OFFSITE DOSE CALCULATION MANUAL

GRAND GULF NUCLEAR STATION

Revision No. 4

MARKUP

vii

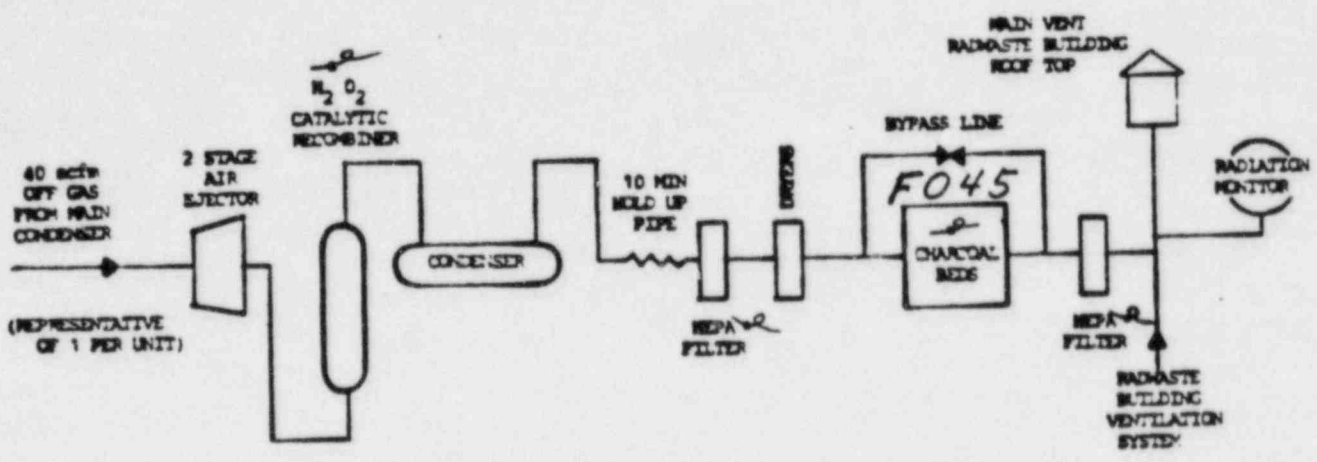
Insert A →

~~The essential components of the GASEOUS RADWASTE TREATMENT (OFFGAS) SYSTEM for the OPERABILITY requirement of RETS Specification 3/4.11.2.4 are indicated below by an asterisk (\*).~~

NOTES →

- 1. ~~The essential components included above are those necessary to process gaseous radwaste prior to discharge to the environment.~~
- 2. ~~The charcoal beds may be bypassed provided the limits of Technical Specification 3.11.2.1 are not exceeded. The charcoal beds will be used as much as possible to ensure releases are as low as reasonably achievable.~~

Insert A to Section 2.5  
Gaseous Radwaste Treatment System  
Page 2.0-35

The instruments required to be checked by RETS 3/4.11.2.4 to ensure that the GASEOUS RADWASTE TREATMENT (OFFGAS) SYSTEM is functioning are:

1. Absorber train bypass switch (IN64-HS-M611)
2. Bypass valve indication (IN64-F045)

When the absorber train bypass switch is in the TREAT position and the bypass valve indicates closed, the GASEOUS RADWASTE TREATMENT (OFFGAS) SYSTEM is functioning.
